James A. FitzPatrick Nuclear Power Plant
Renewed Facility Operating License No. DPR-59
NRC Docket No. 50-333

Subject: Response to Request for Additional Information in support of License Amendment Request – Proposed Changes to the Technical Specifications to Primary Containment Hydrodynamic Loads

Response to FitzPatrick request for additional information: Amendment Request for Change to the Technical Specifications to Revise the Allowable Value for Reactor Water Cleanup (RWCU) System Primary Containment Isolation (EPID: L-2019-LLA-0190)

Exelon Generation Company LLC
James A. FitzPatrick Nuclear Power Plant
Short-Term Containment Analysis for Zero
Drywell-to-Wetwell Pressure Differential

Figure 8. Total and Net Vertical Forces (0 – 20 sec), Zero ΔP .

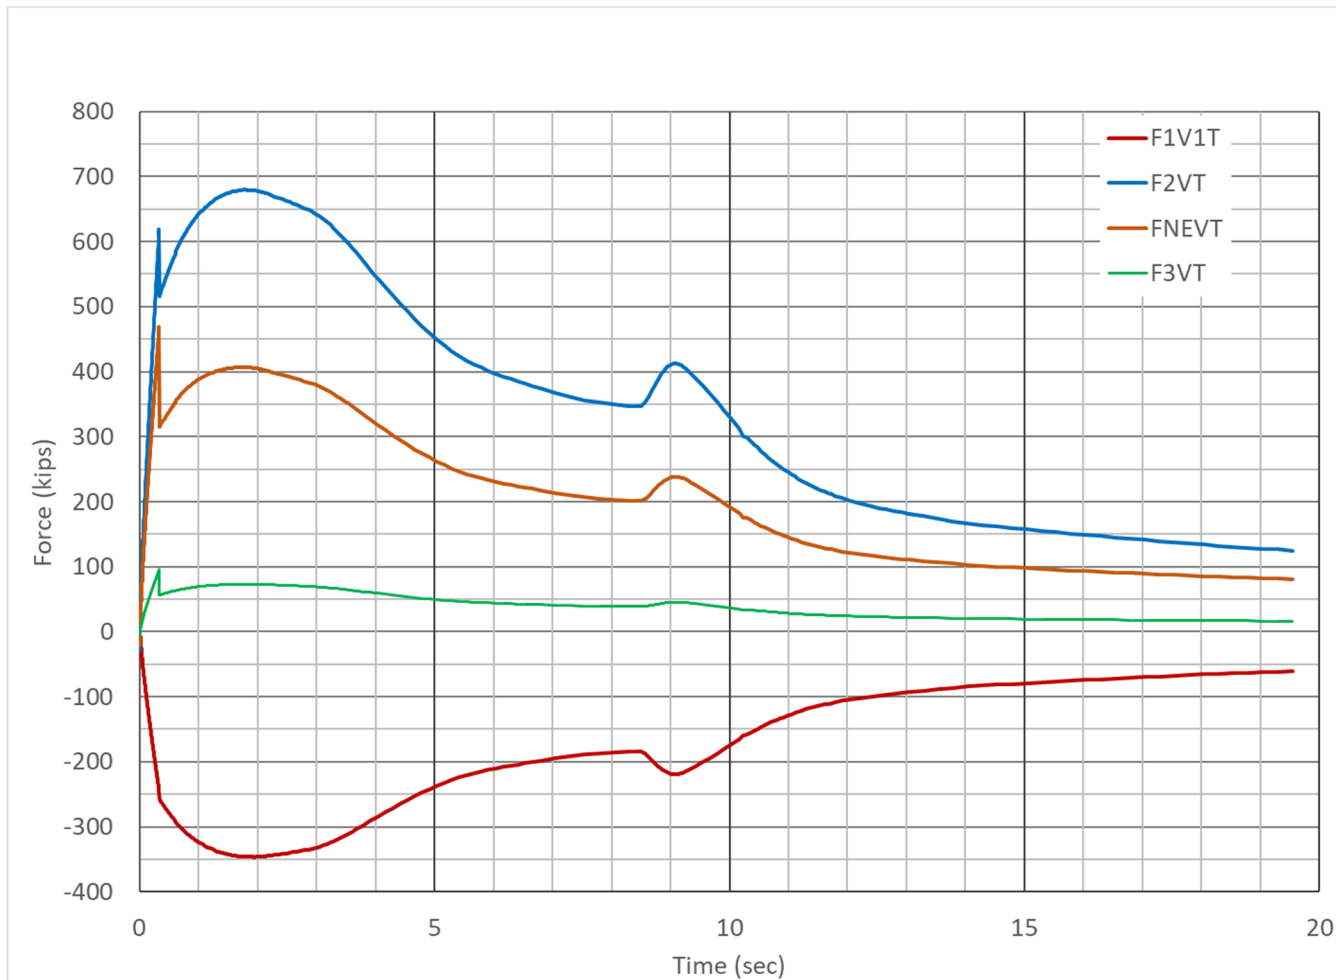
- (c) Based on the proposed TS changes, provide bounding values of the vent thrust loads based on which the structural analysis given in Attachment 6 of the LAR is performed.

- (a) Assessment of these loads based on the revised containment pressure and temperature response can be found in Section 4.0 of 005N1724 (Attachment 2 of this letter).
- (b) The most limiting pressurization rate based on the proposed TS change can be found in Section 4.1 of 005N1724. The maximum pressurization rate as found in section 4.1 of 005N1724 bounded by the full-scale drywell pressurization rate of 60.48 psi/s.
- (c) Bounding values of the vent thrust loads are provided in Table 2 of 005N1724. The structural evaluation given in Attachment 6 of the LAR considered these loads in Section 5.2.4.

The comparisons in Table 2 show that the vent thrust loads for the downcomer mitre bend (F3V, F3VT and F3H) exceed the current design and licensing basis loads. All other loads are still less than the loads in the Plant Unique Load Definition report for operating ΔP .

The vent thrust loads are plotted in Figure 1 through Figure 8. The pressure histories used in calculating the vent thrust loads are plotted in Figure 9 and Figure 10.

Figure 11. Containment Peak Pressure.

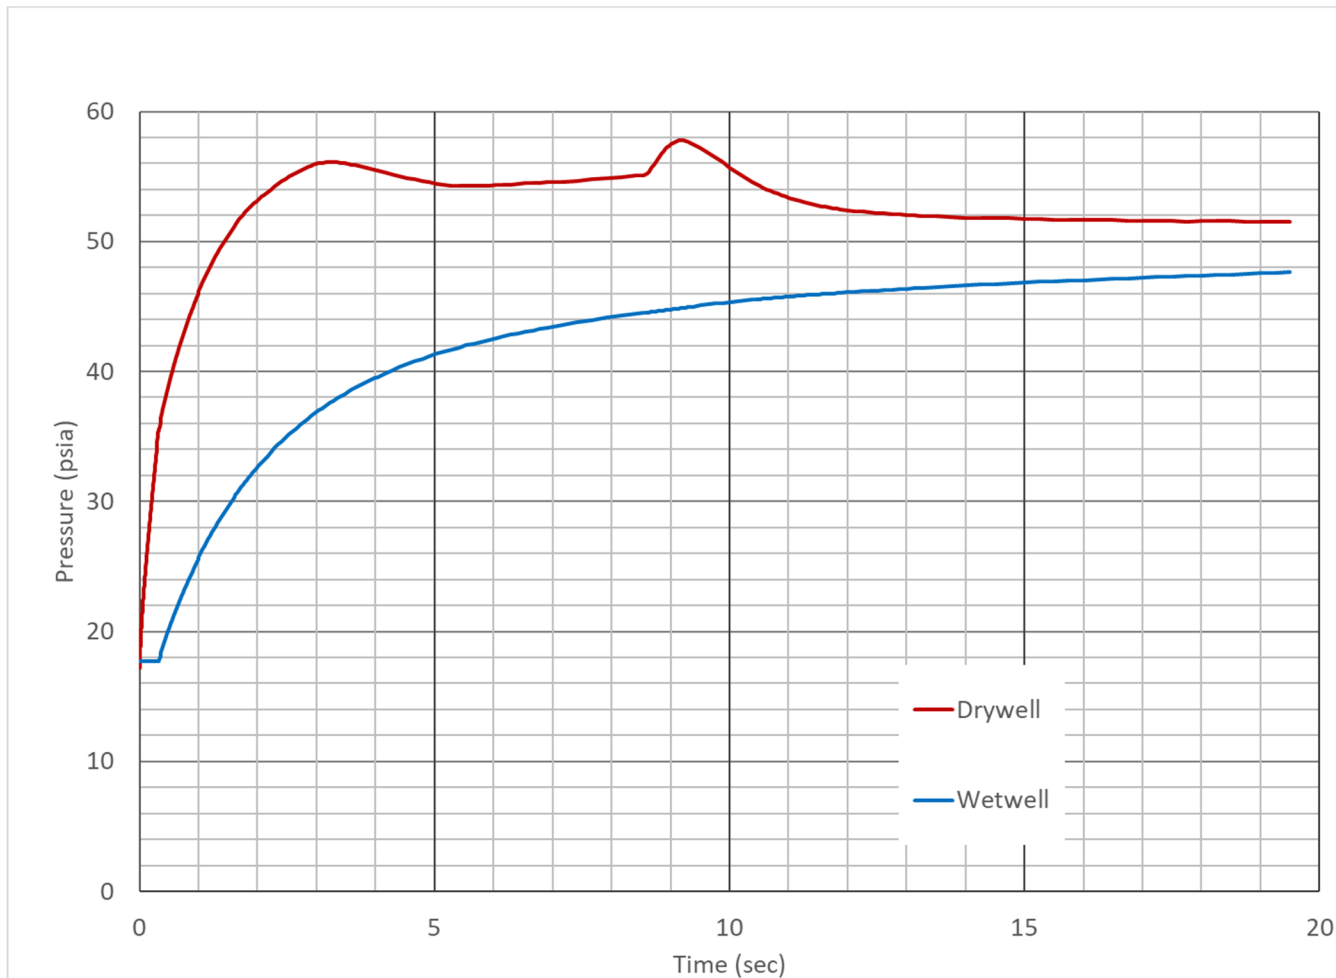
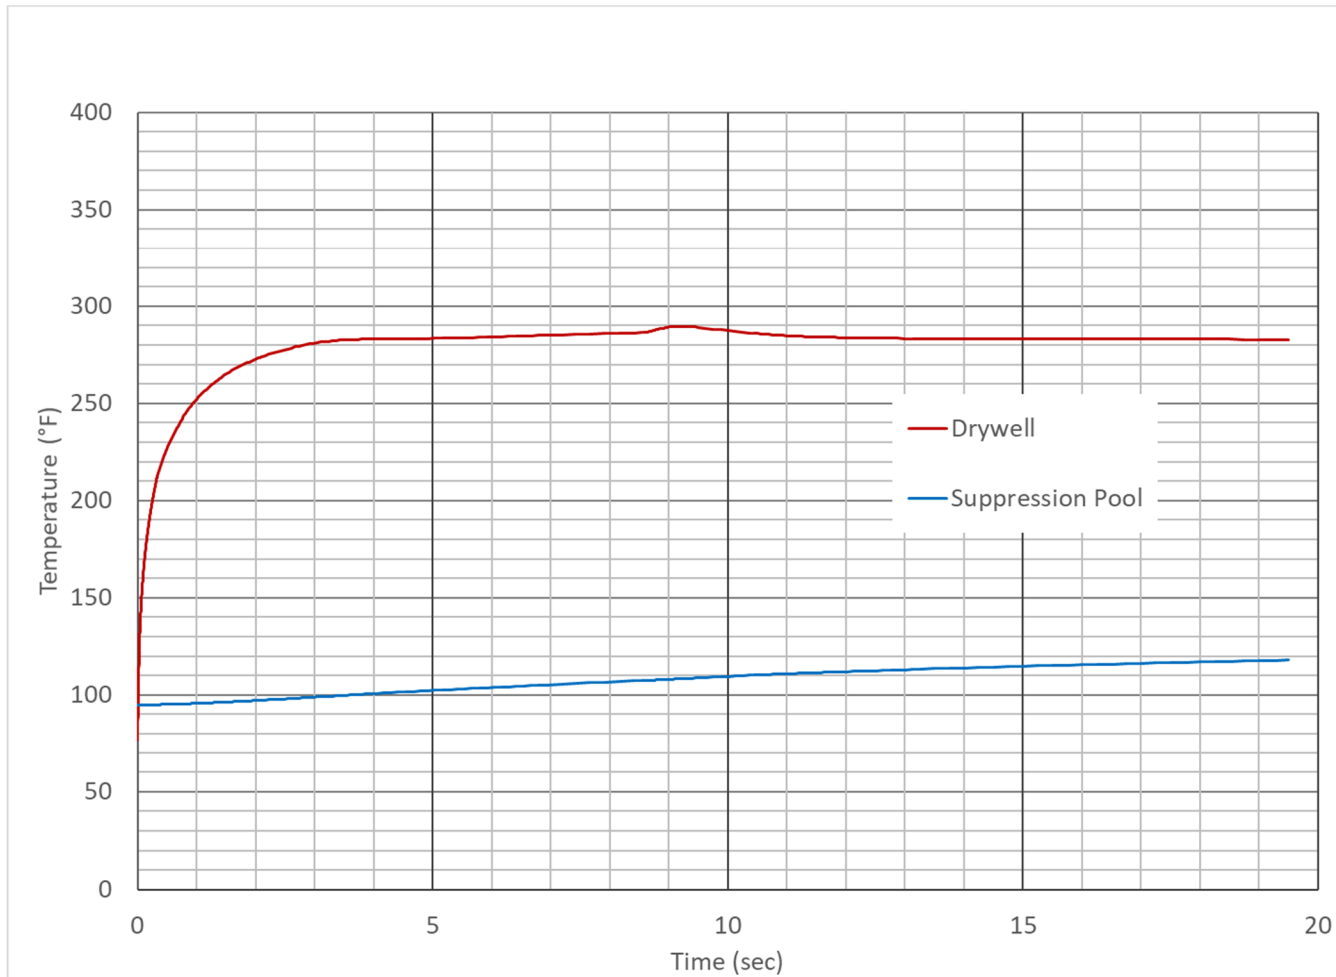
Provide containment pressure and temperature response evaluation and results, both graphs and peak values, for the above cases based on the proposed change in the suppression pool TS maximum level. In case all of the above 4 cases are not re-analyzed, provide the results of the most limiting case with quantitative justification showing that it bounds the remaining 3 cases.

Section 5.0 of 005N1724 (Attachment 2 of this letter) provides justification as to why above cases 1 and 2 are the bounding cases for this analysis. Containment peak pressure and temperature were recalculated for both cases and the results are provided in Table 3 of 005N1724. The bounding pressure and temperature histories are plotted in Figure 11 and Figure 12 of 005N1724.
